Major Modification 26-0340 proposes to allow a second development option on an approximately 37.86-acre area (located within folio no. 62472.0000) on the north of the northwest quadrant of the I-4 Interchange and County Road (CR) 579 (also known as Mango Road).

APPLICATION NUMBER: MM 26-0340 (Revised)

AGENCY REVIEW COMMENT SHEET

Unincorporated Hillsborough County Rezoning Consistency Review	
Hearing Date: May 26, 2026 Report Prepared: May 15, 2026	Case Number: MM 26-0340 Folio(s): 62472.0000 General Location: North of East Sligh Avenue, south of Buster Bean Drive and west of County Road 579
Comprehensive Plan Finding	INCONSISTENT
Adopted Future Land Use	Residential-4 (4 du/ga; 0.25 FAR) *Pending HC/CPA 25-36 to Suburban Mixed Use-6 (6 du/ga; 0.25/0.35/0.50 FAR)
Service Area	Rural *Pending HC/CPA 25-35 to expand the Urban Service Area
Community Plan(s)	Thonotosassa
Rezoning Request	Major Modification (MM) to Planned Development (PD 98-0667) to allow the existing use to continue or to develop three 250,000 square foot warehouse buildings
Parcel Size	38 ± acres
Street Functional Classification	East Sligh Avenue – County Collector Buster Bean Drive – Local County Road 579 – County A

8.2 Proposed Site Plan (page 4 of 6)

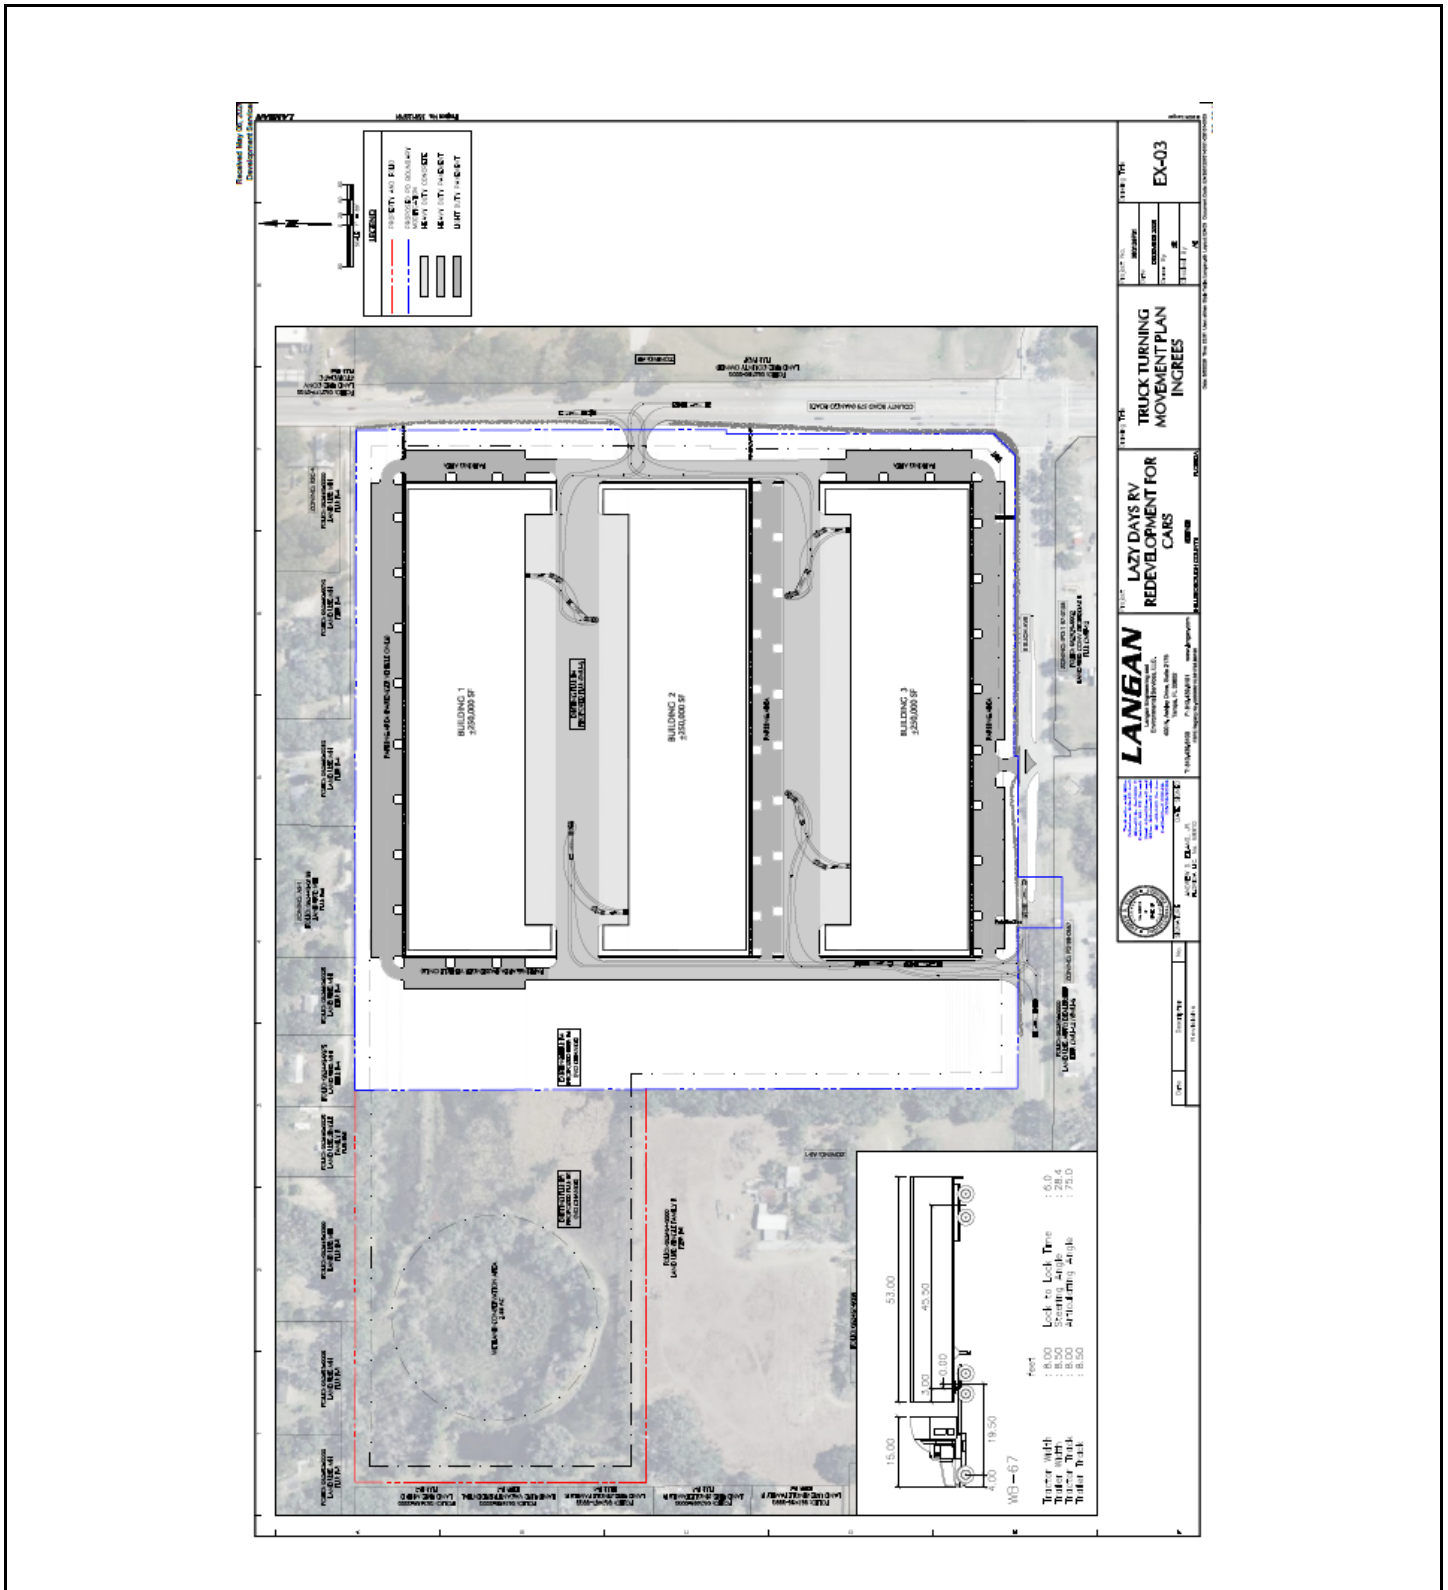
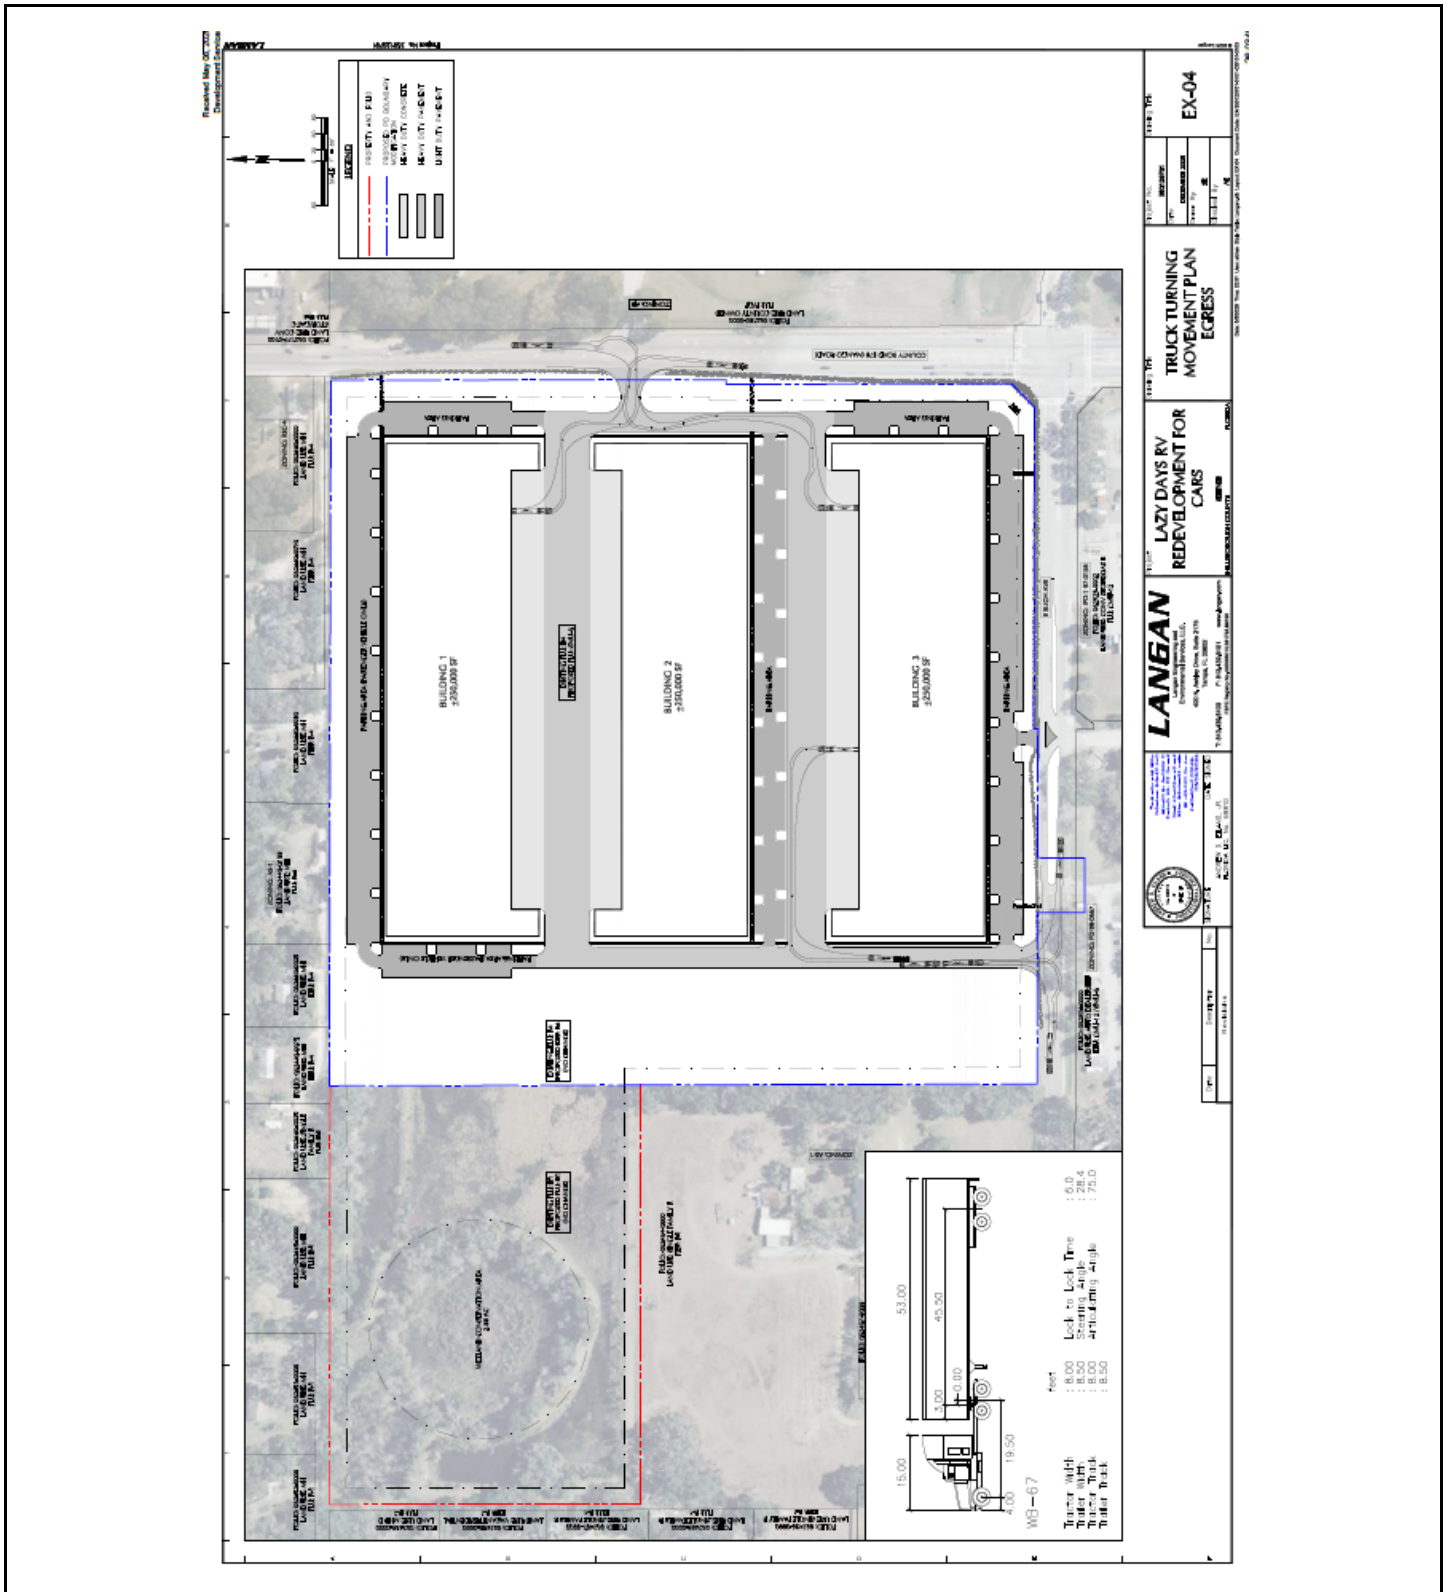
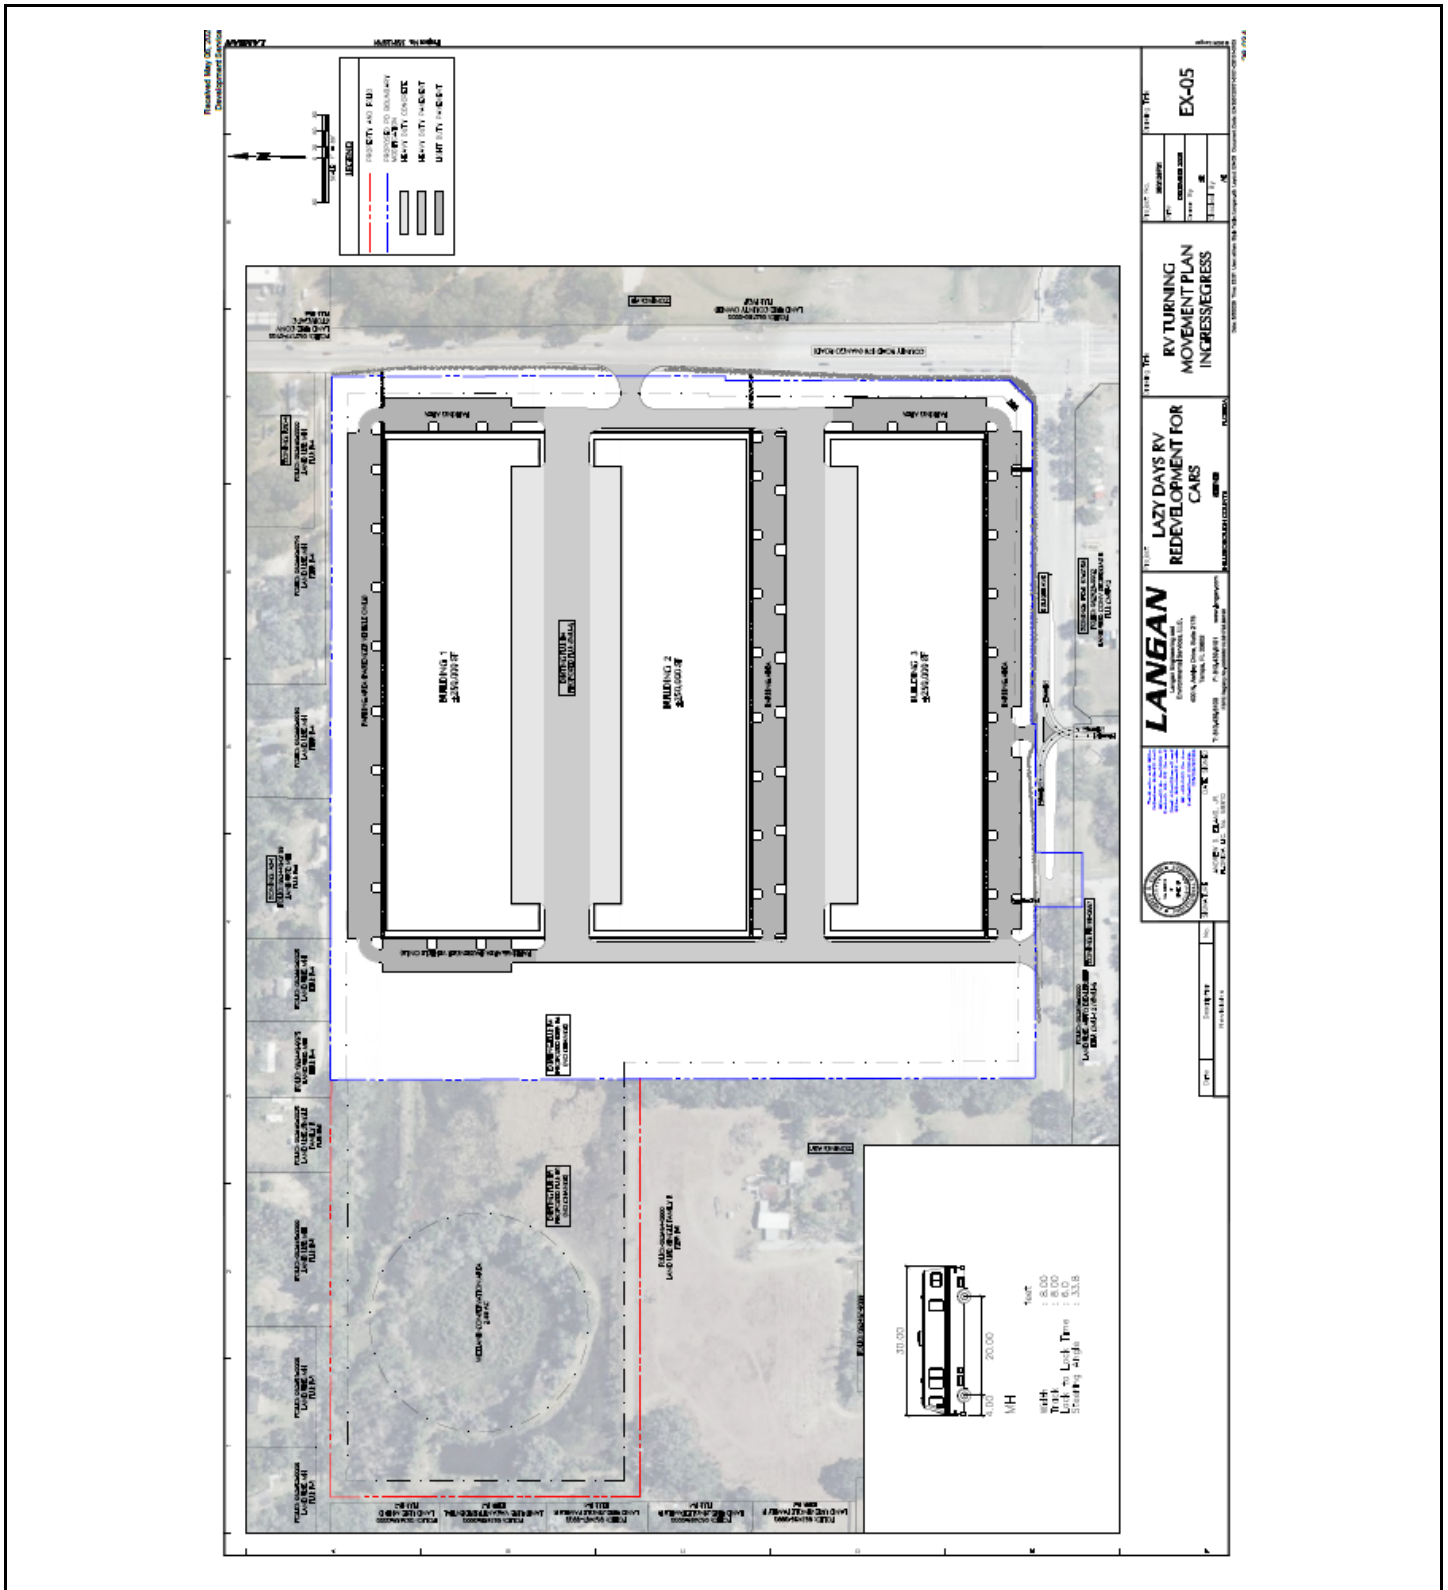
1. Revise the Site Data Table to update the Proposed FAR from “0.45” to “0.46”.
2. Revise the North Setback from “30 feet” to “90 feet”
3. Revise the West Setback from “30 feet” to “190 feet”
4. Revise the East Setback from “30 feet” to “80 feet”
5. Revised proposed use from “light industrial” to M zoning district uses.
6. Prior to PD site plan certification, the applicant shall:
 - o Revise Sheet EX-2 of the PD site plan to label the proposed separator with a label reading “Proposed Separator – See Conditions of Approval”.
7. Remove Sheets EX-3 through EX-5 which are intended to be exhibits of a technical nature and are not intended to be regulating/binding site plans.

- Prior to PD site plan certification, the applicant shall:
 - Revise Sheet EX-2 of the PD site plan to label the proposed separator with a label reading "Proposed Separator – See Conditions of Approval".
 - Remove Sheets EX-3 through EX-5 which are intended to be exhibits of a technical nature and are not intended to be regulating/binding site plans.
